Bulker Q&As and CIs on the IACS CSR Knowledge Centre

Technical Background of Ch 3 Sec 6 [5.2.1] of CSR for Bulker

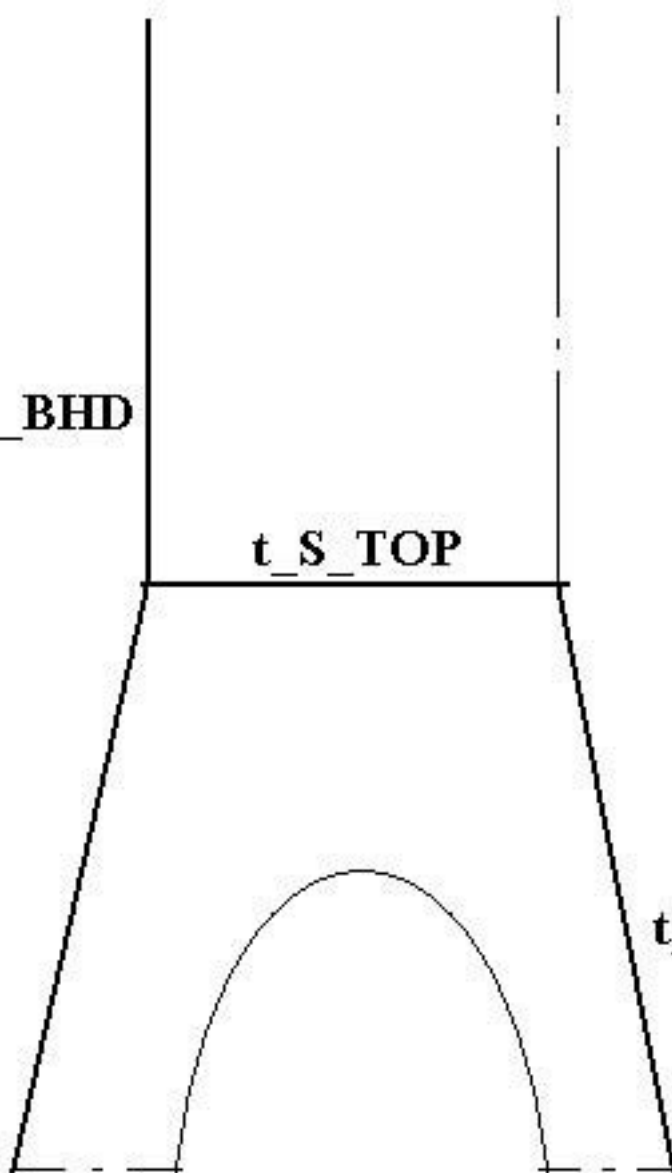
The web stiffener of the primary supporting member (PSM) is provided to prevent the buckling failure of the web plate of PSM.

Even if the buckling failure occurs in the web plate of PSM, the web stiffener has to withstand the buckling loads. For that reason, the stiffness of the web stiffener is always larger than that of the web plate of PSM.

Now, the ratio of the stiffness of the web stiffener to that of the web plate of PSM sets to C and the web stiffener is assumed to be of flat bar with thickness “t” and depth “h”

The critical value C varies depending on the aspect ratio of web plate. Here, the critical value C is taken to 20, based on the actual designs. Then, we can get the following formula.

The ratio of thickness and height of flat bar varies to 135 to 80 which are obtained from the current design, then, $\frac{h}{b} = 0.067 \text{ to } 0.095 \cong \frac{1}{15} \text{ to } \frac{1}{10}$ can be obtained.

The value “1/12” is the average value of $\frac{h}{b}$ above.

Considering the actual design, it was found that this relationship between web stiffener height and panel length can apply to web stiffeners with flat bar fitted to all PSM.

Then, to simplify this relationship, the web stiffener length l has been used instead of b.

As a conclusion, CSR has been adopted the last sentence of the requirement of Ch 3 Sec 6 5.1.2 that the depth of web stiffener is to be more than 1/12 of stiffener length.

KC#534

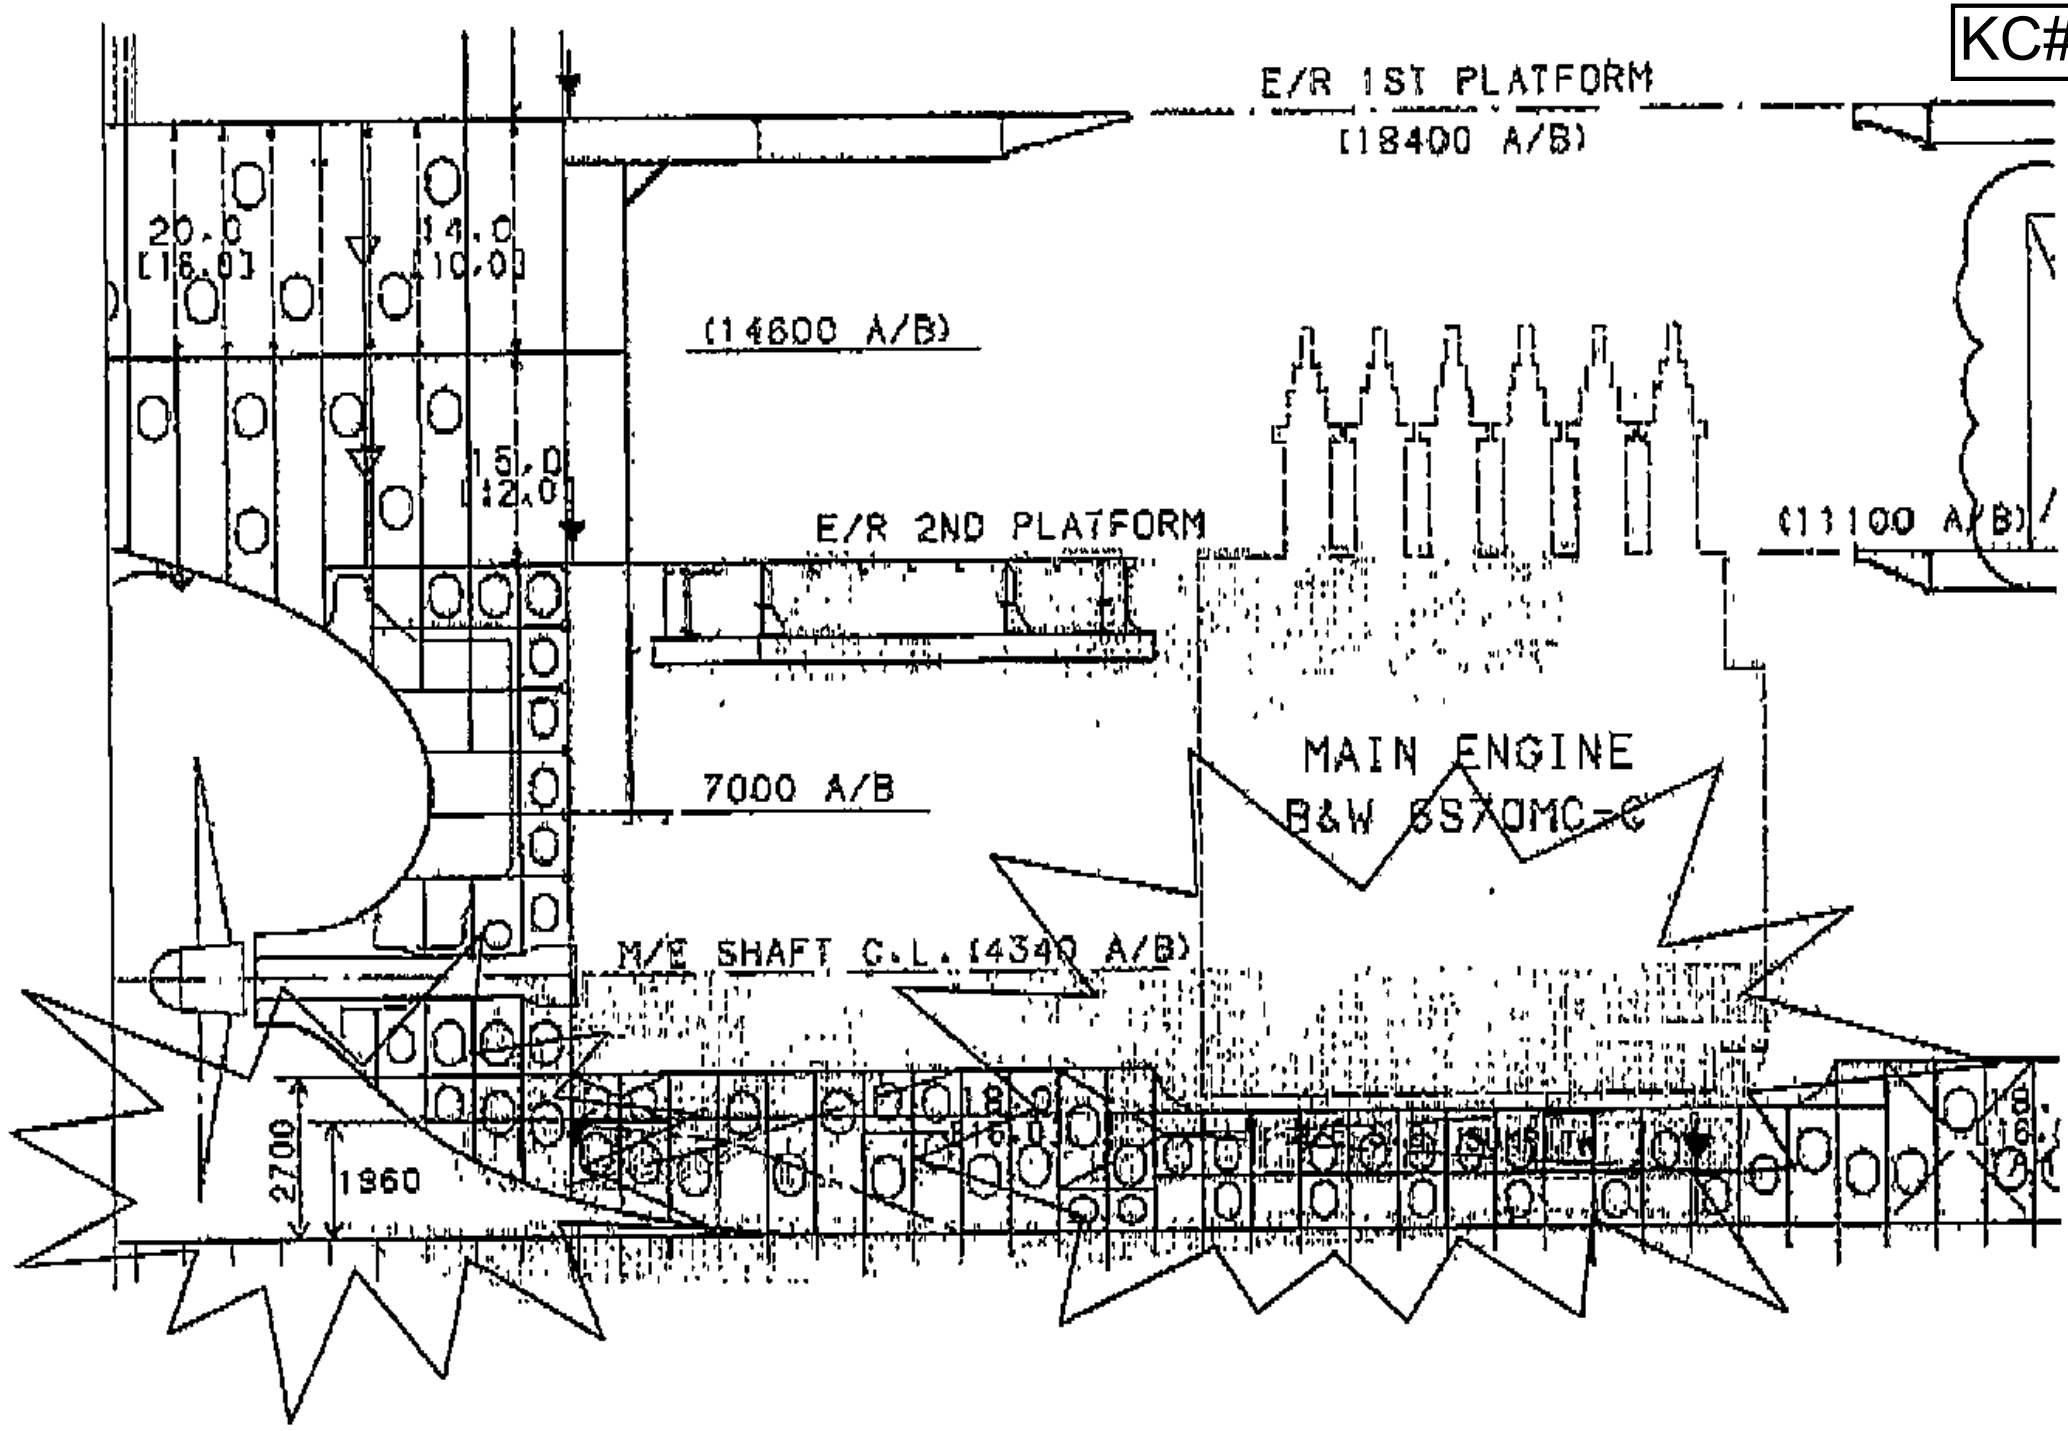
534 attc	3/6.6.1.3	CI	Position of the main propulsion machinery	2007/10/23	The position where the main propulsion machinery is seated is normally recessed from the main double bottom structure in engine room. And the baseline of this seating can be located at which the height from the baseline is less than required. Please refer to the sketch as an example (Moulded of this ship is 45m). In this circumstance, we would like to have your confirmation whether the above arrangement is acceptable or not for the SOLAS and CSR points of view. In addition, we would like to have your general interpretation on the above regulations such as the extent of exemption, necessity of bottom damage calculation, etc.	The minimum height for the double bottom is defined in CH9, Sec3, 2.1.2. The proposed arrangement with a reduced double bottom height in way of the main engine is acceptable provided the lateral extent is limited to the M/E breadth and by lateral tight girders for the CSR for bulk carriers view point and provided the Administration agrees for SOLAS view point. The rigidity of the engine seating and the surrounding bottom structure must be adequate to keep the deformations of the system due to the loads within the permissible limits, given by the engine manufactures. In special cases, proof of deformations and stresses may be required.	Y

SECTION MODULUS CALCULATION (IRS, Part 3 ,Chapter 3, Section 4)

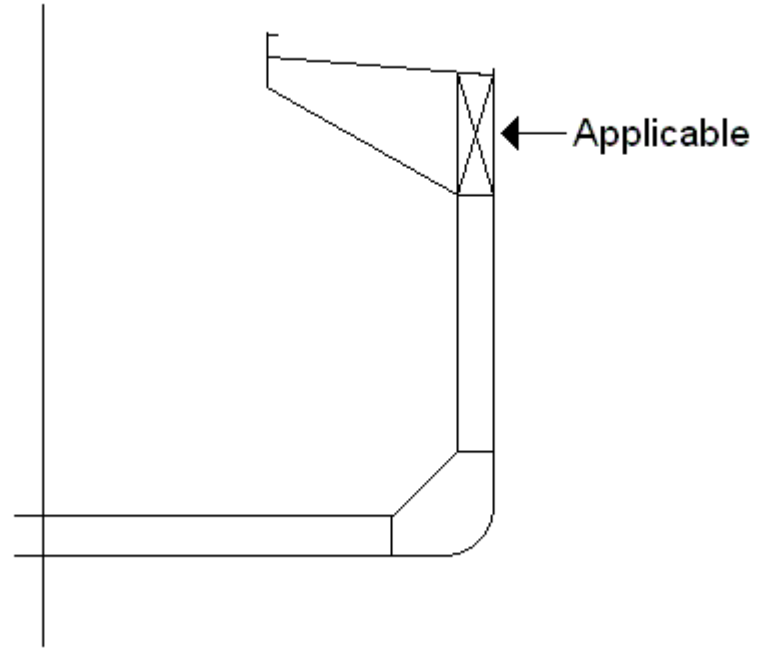
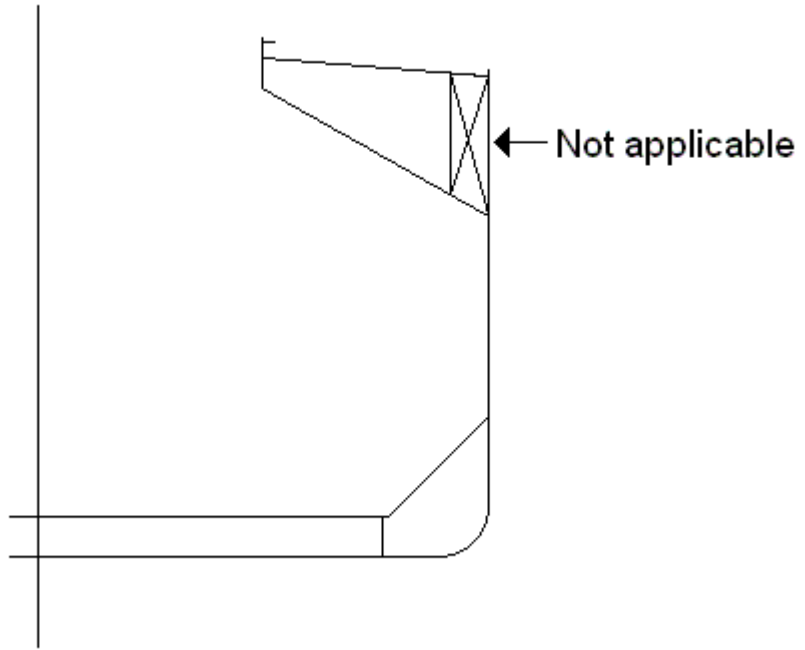
Please arrange to clarify on the above and advice on the EFFECTIVE WIDTH OF ATTACHED PLATING TO BE CONSIDERED FOR PRIMARY MEMBERS.

KC#702

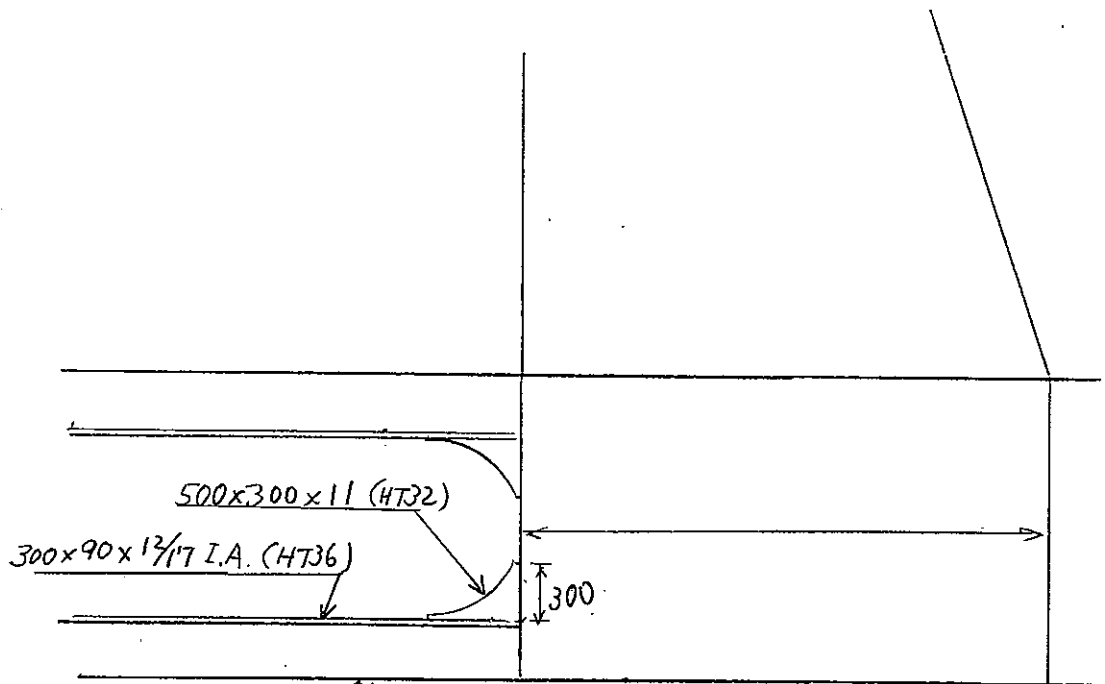
1. The section of the bracket and the stiffener;
 - 1-a. at the end of the stiffener.
 - 1-b. at the mid-point of the free edge of the bracket.

In case 1, is the snipped flange of the stiffener included in the calculations?

2. The section of the bracket;
 - 2-a. normal to the free edge of the bracket.
 - 2-b. at the end of the stiffener.
 - 2-c. attached to the stiffener.
 - 2-d. smaller of 2-b and 2-c.

→ BRACKET SIZE TO BE INCREASED TO 300x16 HT32 FROM 300x11 HT32

→ IF MATERIAL FACTOR SHOULD BE CONSIDERED, TO BE INCREASED TO 300x17 HT32

KC#827

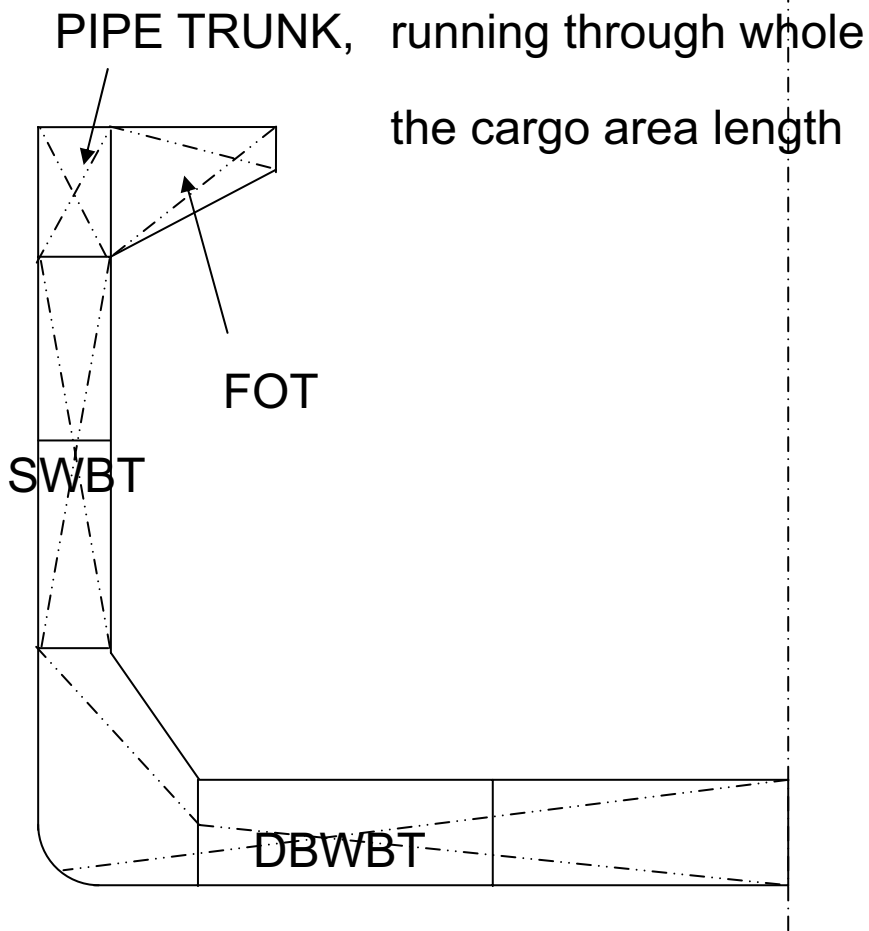
KCID No.	Ref.	Type	Topic	Date completed	Question/CI	Answer	Attachment
827 attc	3/6.7.2.1	CI	void space	2009/3/3	<p>Please refer to the attached sketch of a bulk carrier with double side skin construction. This bulk carrier has FOT and pipe trunk in the topside area. The pipe trunk is considered as void space. Ch3 Sec6, 7.2.1 requires as follows; Where the double side space is void, the structural members bounding this space are to be structurally designed as a water ballast tank according to Ch 6. In the bulk carrier, FOTs are arranged with cargo hold length and the pipe trunk is running through whole the cargo area length. According to our calculation based on the above, the dynamic pressure in the long pipe trunk is estimated about twice the large pressure in FOTs and excessive scantlings are required by the calculation based on the pipe trunk pressure. However, taking into account the technical background of Ch3 Sec6, 7.2.1 as quoted below, requiring the above-mentioned excessive scantling is irrational;</p> <p>If the double side skin part is to be used as a void space, and cargo of high density is to be carried in the cargo holds, then local loads are not presumed to act on the side structure of the cargo hold on the double skin side. Even in such cases, appropriate thickness exceeding the minimum thickness is considered necessary. As a conclusion, even if the double skin side part is a void space, it is treated as a ballast tank and assessment of local strength is specified. In this bulk carrier, the longitudinal bulkhead can be considered appropriately by the estimation of the pressure in FOT. Therefore, we are of the opinion that the longitudinal bulkhead between the pipe trunk and the FOT has an appropriate construction by calculating FOT internal pressure, therefore, the bulk carrier is in compliance with Ch3 Sec6, 7.2.1, without calculation of the pipe trunk internal pressure.</p>	<p>It was not the intention of the CSR to derive irrational dimensions for void bounding structures. We suggest to use the corresponding cargo hold length for L_H in the formula for inertial water ballast pressure. We will make a rule change proposal to eliminate this drawback.</p>	Y

[Our design concept]

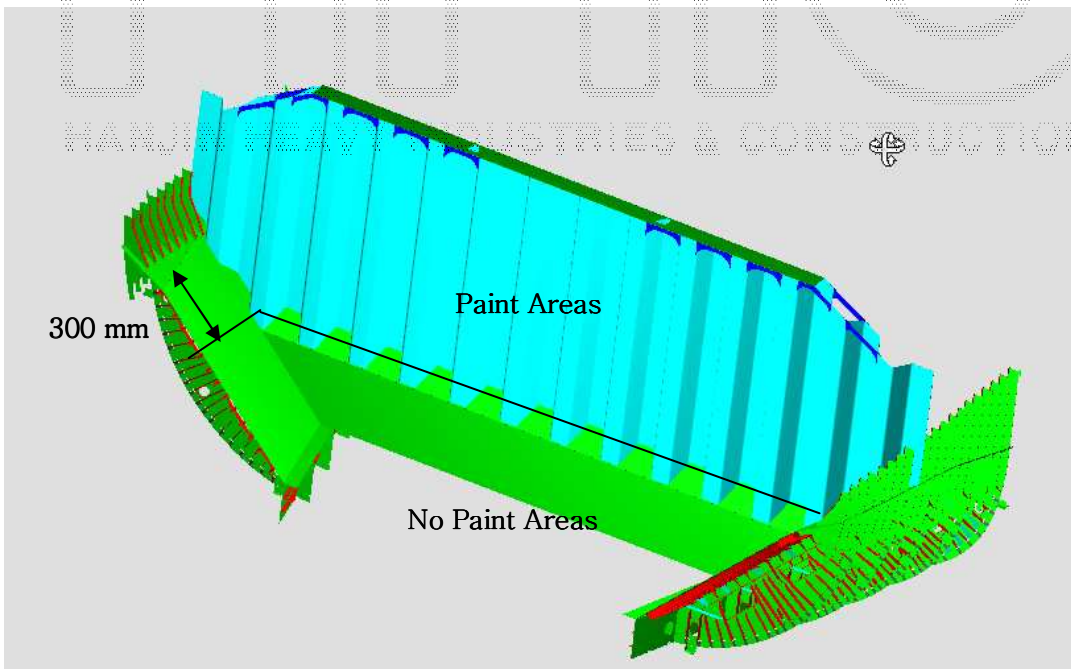
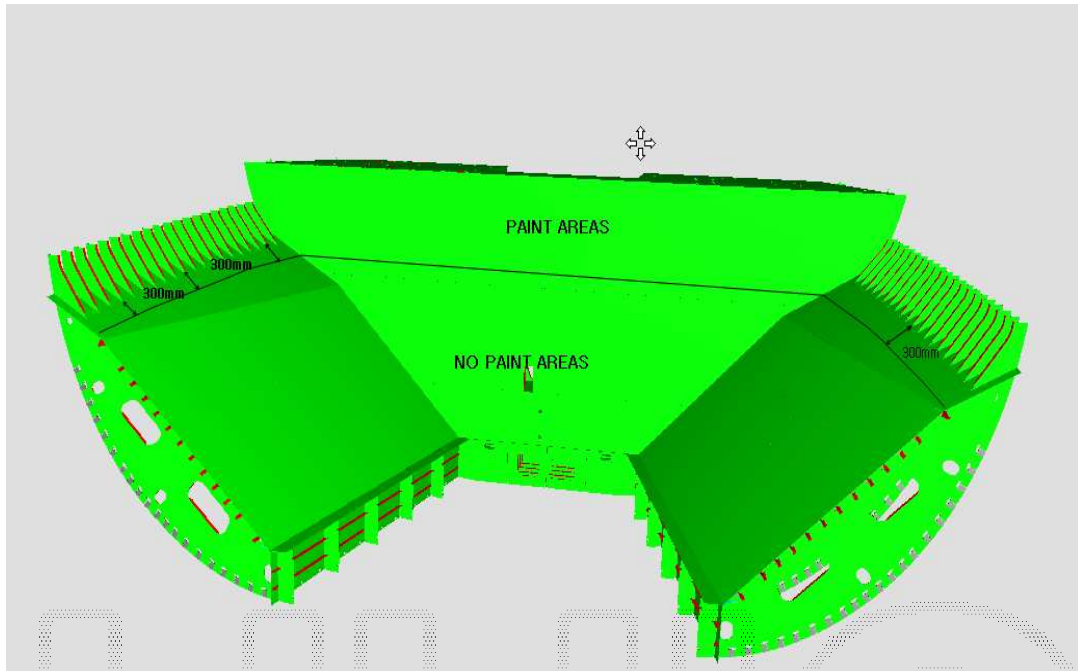
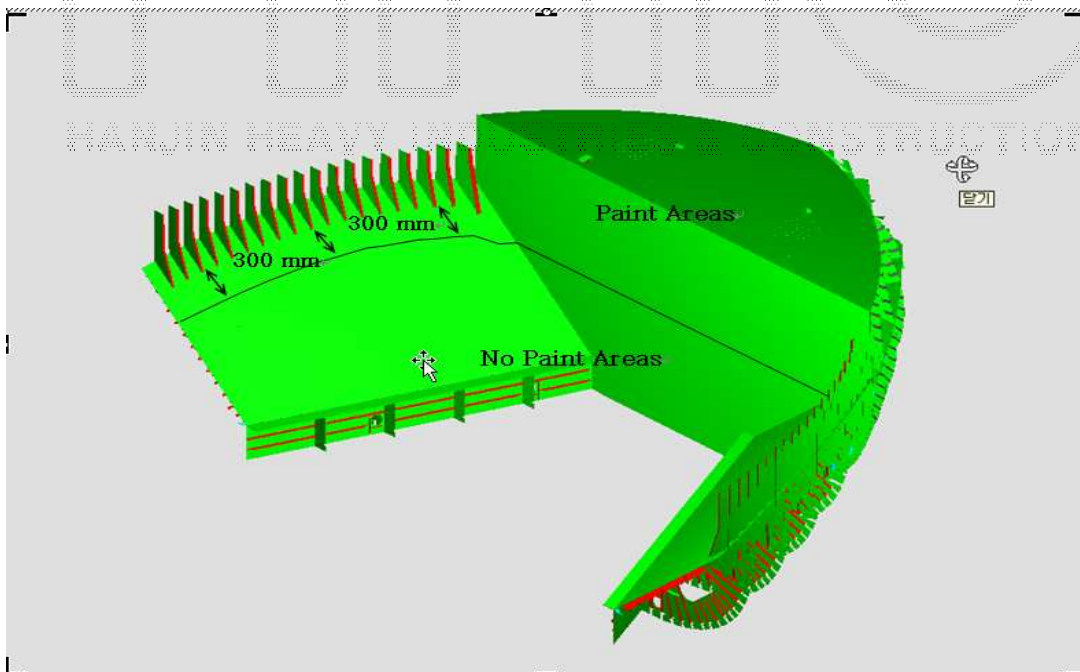
- 1) In case of side areas, the areas to be coated are “the inner side plating, the internal surfaces for the topside tank sloping plates” to “the hopper tank sloping plates for a distance of 300mm below the frame end bracket” according to 1.3.3. (Please refer to detail samples as follows)
- 2) In case of transverse bulkhead areas, the areas to be coated are above an horizontal level located at a distance of 300mm below the frame end bracket for single side bulk carrier according to 1.3.4. (Please refer to detail samples as follows)
